CONSTRUCTION PLANS
FOR THE
CITY OF WINTER GARDEN

BOYD STREET PARKING LOT

RECORD DRAWING

BOYD STREET PARKING GEOMETRY, GRADING AND DRAINAGE PLAN

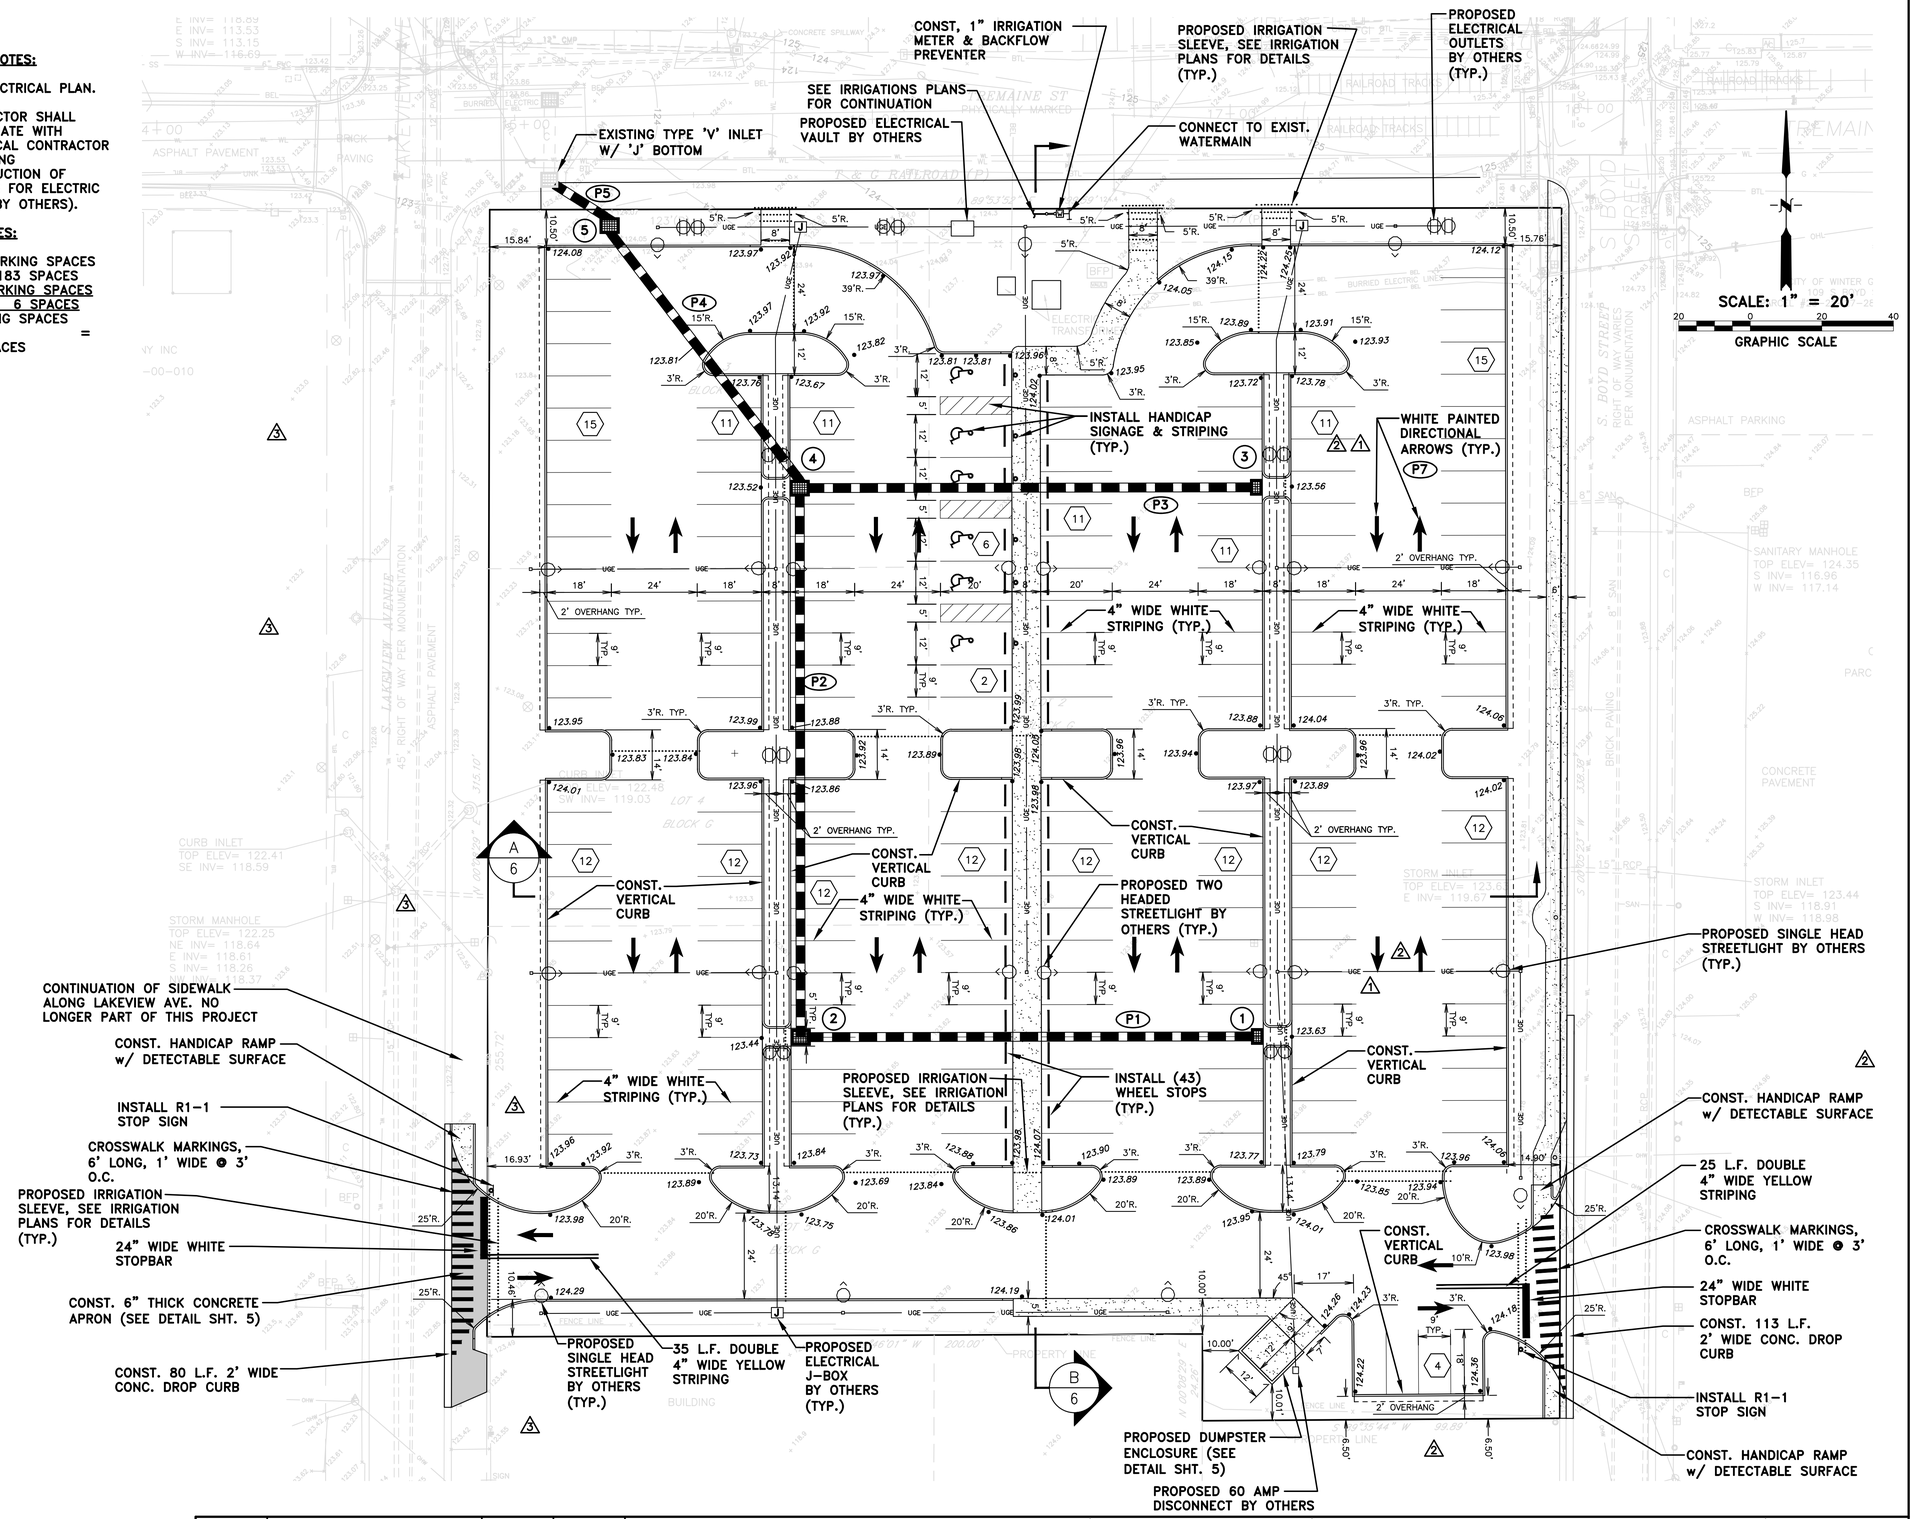
(1) CONST. TYPE 'C' INLET, OPEN BOTTOM, GRAVEL FILLED
TOP EL. = ~~123.50~~ 123.42
W. INV. EL. = ~~119.55~~ 119.57
STRUCTURE BOTTOM EL. = ~~117.55~~ 117.57

(2) CONST. TYPE 'D' INLET, OPEN BOTTOM, GRAVEL FILLED
TOP EL. = ~~123.40~~ 123.43
E. INV. EL. = ~~119.55~~ 119.56
N. INV. EL. = ~~119.55~~ 119.56
STRUCTURE BOTTOM EL. = ~~117.55~~ 117.56

(3) CONST. TYPE 'C' INLET, OPEN BOTTOM, GRAVEL FILLED
TOP EL. = ~~123.50~~ 123.36
W. INV. EL. = ~~119.55~~ 119.54
STRUCTURE BOTTOM EL. = ~~117.55~~ 117.54

(4) CONST. TYPE 'D' INLET, OPEN BOTTOM, GRAVEL FILLED
TOP EL. = ~~123.40~~ 123.38
E. INV. EL. = ~~119.55~~ 119.56
S. INV. EL. = ~~119.55~~ 119.56
NW. INV. EL. = ~~119.55~~ 119.57
STRUCTURE BOTTOM EL. = ~~117.55~~ 117.56

(5) CONST. TYPE 'D' INLET
TOP EL. = ~~124.50~~ 124.55
WIER EL. = ~~121.80~~ 121.55
SE. INV. EL. = ~~119.55~~ 119.54
NW. INV. EL. = ~~119.55~~ 119.40
STRUCTURE BOTTOM EL. = ~~117.55~~ 117.53
